The Commission has issued the enclosed Amendment No. 41 to Facility Operating License No. DPR-56 for the Peach Bottom Atomic Power Station, Unit No. 3. The amendment consists of changes to the Technical Specifications and is in response to your request dated December 19, 1977, as supplemented August 30, 1977, January 17, February 2 and 17, May 8 and 11, 1978.

PEACH BOTTOM ATOMIC POWER STATION UNIT NO. 3

Amendment No. 41
License No. DPR-56

ATTACHMENT TO LICENSE AMENDMENT NO. 41

Figure 3.5.1.G Maximum Average Planar Linear Heat Generation Rate Versus Planar Average Exposure

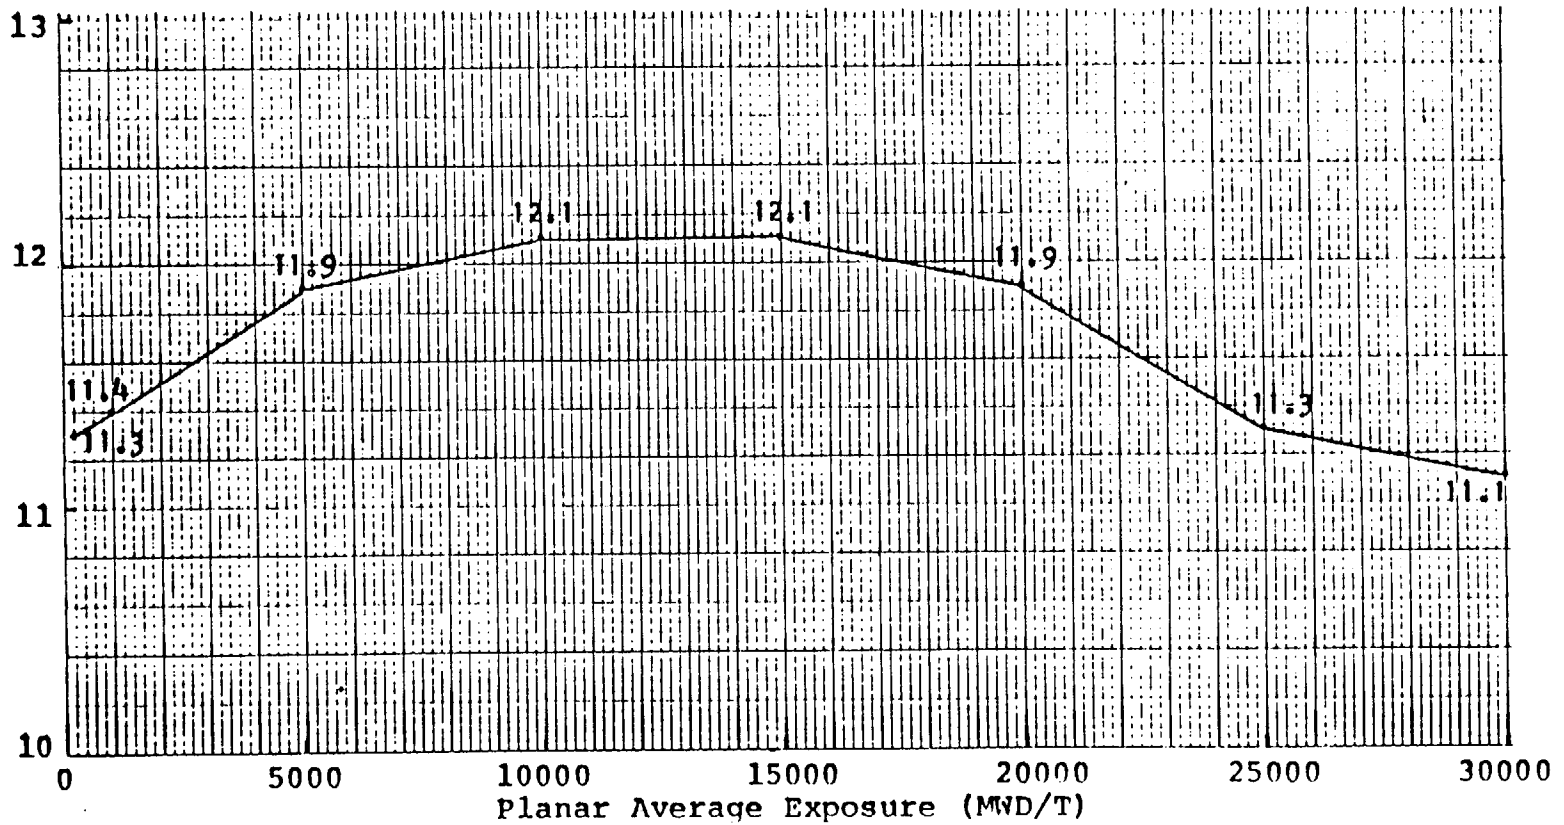
During power operation, the APLHGR for each type of fuel as a function of average planar exposure shall not exceed the limiting value shown in Figure 3.5.1.A, B, C, D, F, & G, as applicable. If at any time during operation it is determined by normal surveillance that the limiting value of APLHGR is being exceeded, action shall be initiated within one (1) hour to restore APLHGR to within prescribed limits. If the APLHGR is not returned to within prescribed limits within five (5) hours reactor power shall be decreased at a rate which would bring the reactor to the cold shutdown condition within 36 hours unless APLHGR is returned to within limits during this period. Surveillance and corresponding action shall continue until reactor operation is with the prescribed limits.

The calculational procedure used to establish the APLHGR shown on Figures 3.5.1.A, B, C, D, F, and G is based on a loss-of-coolant accident analysis. The analysis was performed using General Electric (GE) calculational models which are consistent with the requirements of Appendix K to 10 CFR Part 50. A complete discussion of each code employed in the analysis is presented in Reference 4. Input and model changes in the Peach Bottom loss-of-coolant analysis which are different from the previous analyses performed with Reference 4 are described in detail in Reference 8. These changes to the analysis include: (1) consideration of the counter current flow limiting (CCFL) effect, (2) corrected code inputs, and (3) the effect of drilling alternate flow paths in the bundle lower tie plate.
